Project: 226052 DFCI-BIDMC New Cancer Hospital - 1 Joslin Place - Construction
1 Joslin Place
Boston, Massachusetts 02215

RFI #0-PB-124: LBE Column Cap Plate Weld Requirements – Detail 1/S0.06

1 CAP PLATE DETAILS

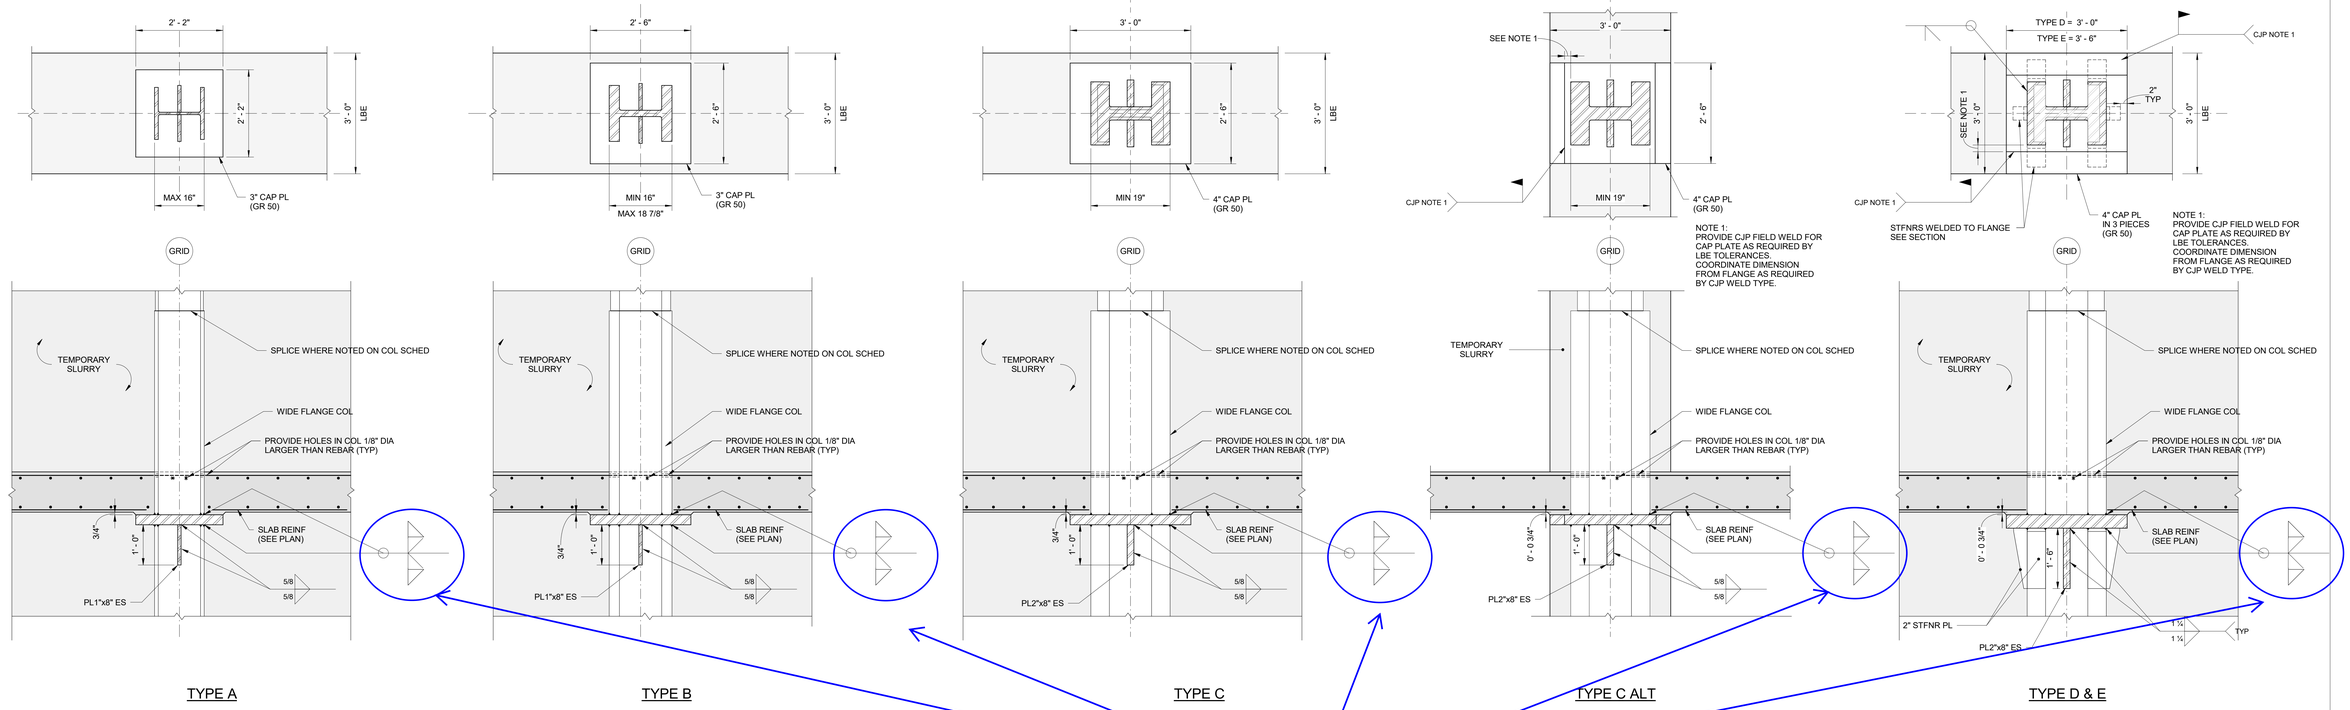
Detail 1/S0.06 indicates the configuration for the LBE column cap plate connection at each applicable garage level. However, the detail does not identify the required weld sizes (fillet size, length, or type) between the LBE column and the cap plate. Weld size is required for both competitive bid purposes and fabrication detailing. Please provide the required weld sizes for these locations

For bidding purposes only, at the floor levels below elevation 35':
1. At the primary lateral system columns (as defined below), provide allowance to develop an average of 50% of the axial tensile yield capacity of the columns.
2. At all other columns, provide allowance to develop an average of 20% of the axial tensile yield capacity of the columns.

Primary lateral system columns include: H-4.1, J.1-4.1, K-4.1, H-5, J.1-5, K-5, C-4.1, C-5, C-7, F.7-2, H.3-2, J.2-2
Final design forces will be provided in an upcoming issuance.
